Urban Design Consultation Response

Application ref: 25/00866/DOC

Proposal: Submission of details to comply with conditions 3 (Materials - Crimble Hall), 4 (Materials) and 11 (AIA - Tree Protection) of planning permission 21/00092/FUL

Site Address: The Crimble Restaurant, Crimble Lane, Heywood, Rochdale OL11 4AD

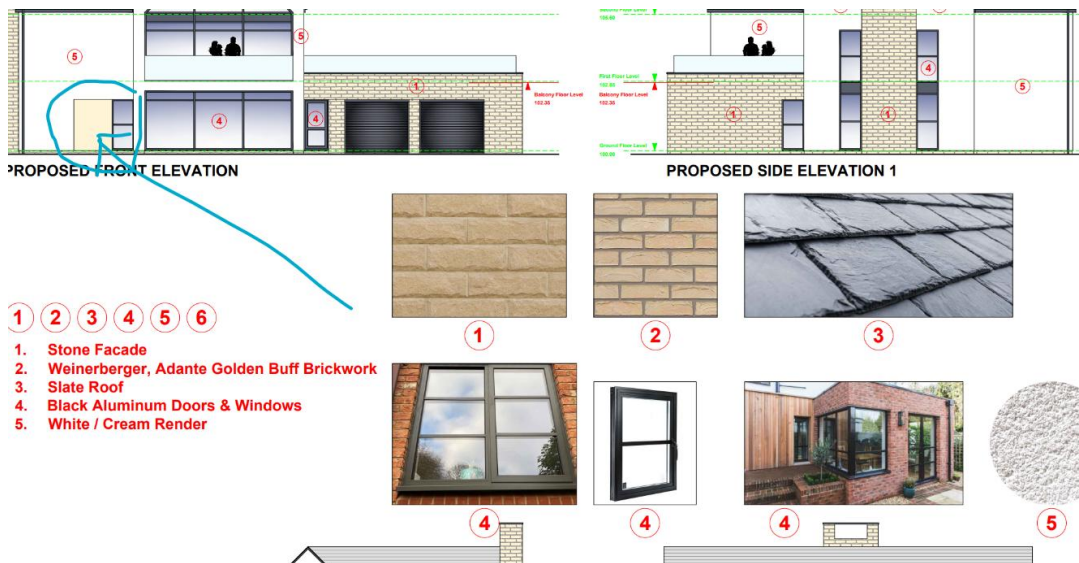
It's not made clear on the plans which material would be used here? -
